May 22, 2018

Mr. Frank DeFrancesco, Chief
Dams and Waterway Section
Pennsylvania Department of Environmental Protection
2 East Main Street
Norristown, PA 19401

**Re: SPLP Response to Comments
Hydrogeological Reevaluation Report
Arch Bishop/South Chester Road HDD (S3-0541)
DEP Permit Nos. E15-862 and E23-524
Westtown and Edgemont Townships
Chester and Delaware Counties, Pennsylvania**

ATTACHMENT 2
WATER SUPPLY ILLUSTRATION

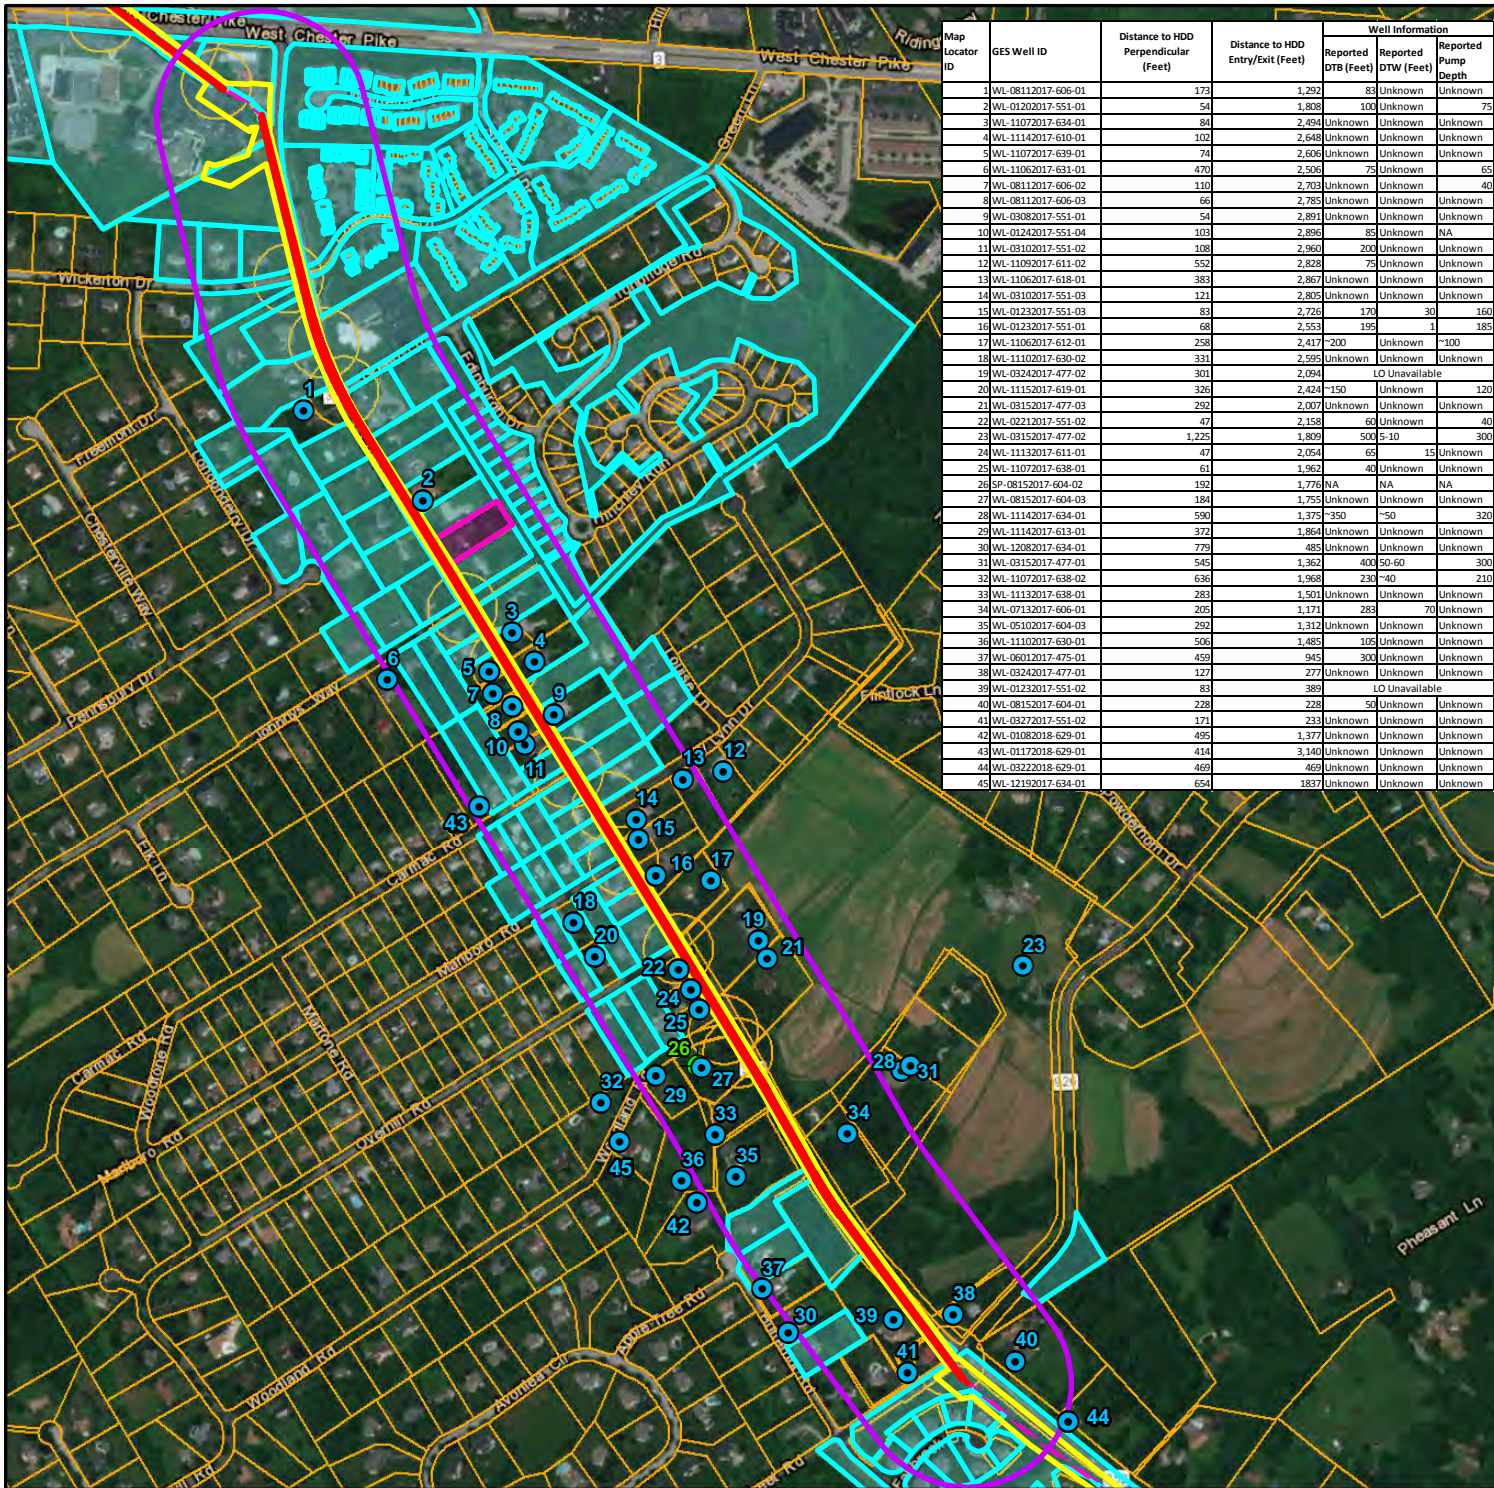
b. A map showing all the private water supplies in the correct, surveyed locations.

The water supply illustration provided as Attachment 2 to this response is an accurate presentation of the known water supply wells. The well locations were recorded by GPS.
